Contra Costa County
Public Works
Department

RE: CEQA Public Noticing Comment Responses
San Pablo Dam Road-La Honda Road Storm Drain and Slide Repair Project
State Clearinghouse No.: 2026050969
Project No.: 0672-6U6272

TREE REMOVAL EXHIBIT			
FILE NO.		SHEET	OF
FILE NAME:		PEN TBL:

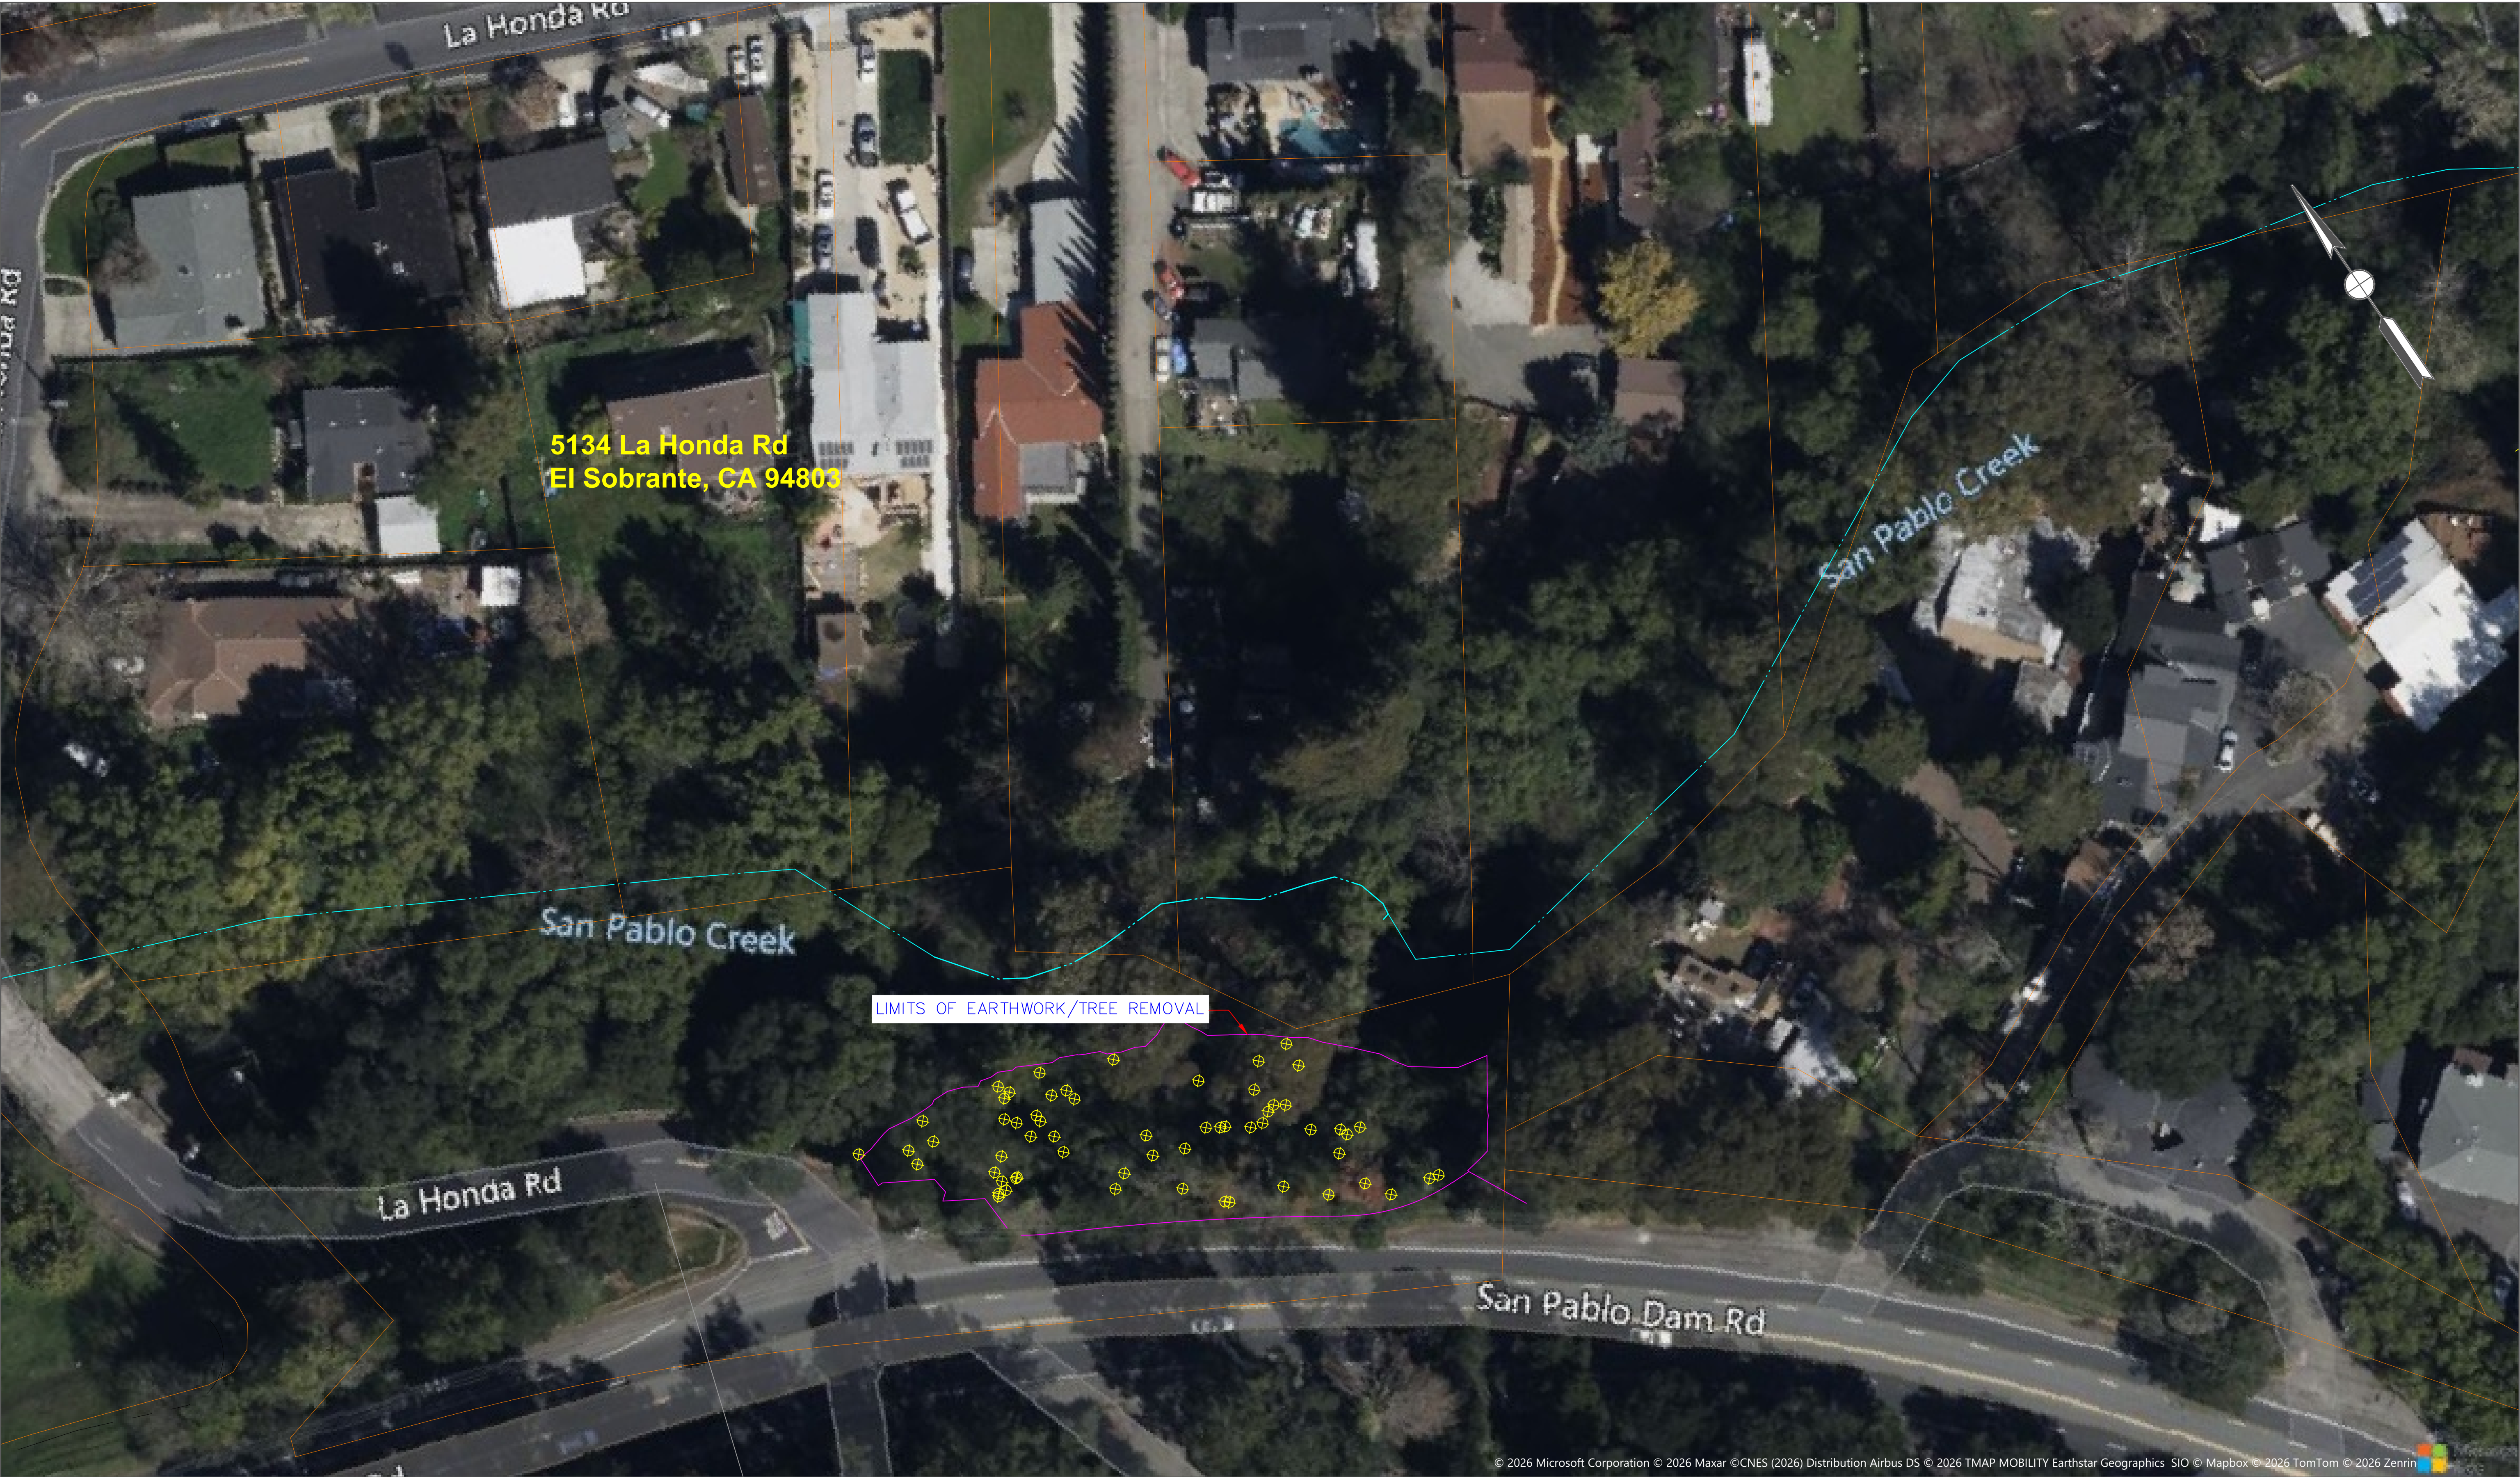
Comment 1: Impact on noise levels and construction noise

Comment 2: Impact on light exposure

General Response: Tree and vegetation removal will be restricted to the project footprint, and there will still be a line of trees retained on the southern side of San Pablo Creek, as well as the northern side of the creek (see Figure 1). The County expects that there will not be a reduction in noise attenuation from the removal of trees given the number of trees that will be retained between the project footprint and neighboring

General Response: Similar to the response for Comment 1, the County expects that there will not be a reduction in light protection from the removal of trees given the number of trees that will be retained between the project footprint and your property (see Figure 1). Additionally, any trees that are removed for the proposed project would be replaced by replanted trees as described above in the General Response to Comment 1.
